APPLICATION NO.	FILING DATE	FIRST NAMED INVENTOR	ATTORNEY DOCKET NO.	CONFIRMATION NO
10/799,635	03/15/2004	Katsunori Nagata	2589-23	8537
23117	7590 04/26/2006		EXAMINER	
NIXON & VANDERHYE, PC			CHOWDHURY, TARIFUR RASHID	
	GLEBE ROAD, 11TH FLOO N, VA 22203	LOOK	ART UNIT	PAPER NUMBER
	,		2871

A I' 4' NI -	A Useratio			
	Application No. 10/799,635	Applicant(s) NAGATA, KATSUNORI			
Office Action Summary	Examiner	Art Unit			
-	Tarifur R. Chowdhury	2871			
The MAILING DATE of this communication app					
Period for Reply					
A SHORTENED STATUTORY PERIOD FOR REPLY IS SET TO EXPIRE 3 MONTH(S) OR THIRTY (30) DAYS, WHICHEVER IS LONGER, FROM THE MAILING DATE OF THIS COMMUNICATION. - Extensions of time may be available under the provisions of 37 CFR 1.136(a). In no event, however, may a reply be timely filed after SIX (6) MONTHS from the mailing date of this communication. - If NO period for reply is specified above, the maximum statutory period will apply and will expire SIX (6) MONTHS from the mailing date of this communication. - Failure to reply within the set or extended period for reply will, by statute, cause the application to become ABANDONED (35 U.S.C. § 133). Any reply received by

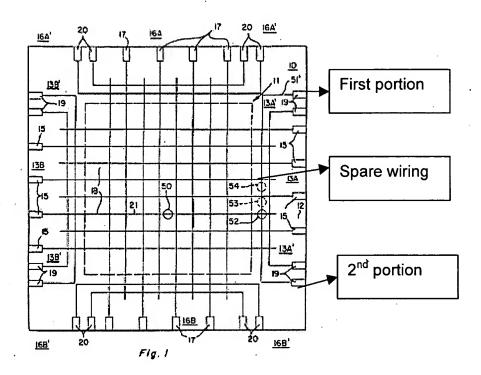
- (b) the invention was patented or described in a printed publication in this or a foreign country or in public use or on sale in this country, more than one year prior to the date of application for patent in the United States.
- 2. Claims 1, 2 and 4 are rejected under 35 U.S.C. 102(b) as being anticipated by Strong, USPAT 4,840,459.
- 3. Strong discloses (col. 3, line 55 col. 2, line 28) and shows in Fig. 1, a display device comprising:
- a display panel comprising a repair line (applicant's spare wiring) with which to repair imperfect connection in a signal wiring,

wherein a terminal portion of the spare wiring is composed of first and second portions that are separated and electrically isolated from each other and located on a same surface of the display panel (see the reproduced Fig. 1 provided below).

Accordingly, claims 1 and 2 are anticipated.

FIG.7

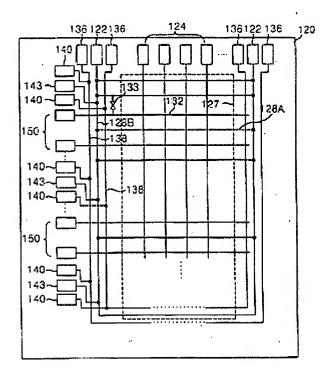
- 4. Claims 1, 2 and 4 are rejected under 35 U.S.C. 102(e) as being anticipated by Moon et al., (Moon), USPAT 6,864,937.
- 5. Moon discloses and shows in Fig. 7, a display device comprising:
- a display panel comprising a dummy signal line (138)((applicant's spare wiring) with which to repair imperfect connection in a signal wiring,

wherein a terminal portion of the spare wiring is composed of first (136) and second (140) portions that are separated and electrically isolated from each other and located on a same surface of the display panel.

Accordingly, claims 1 and 2 are anticipated.
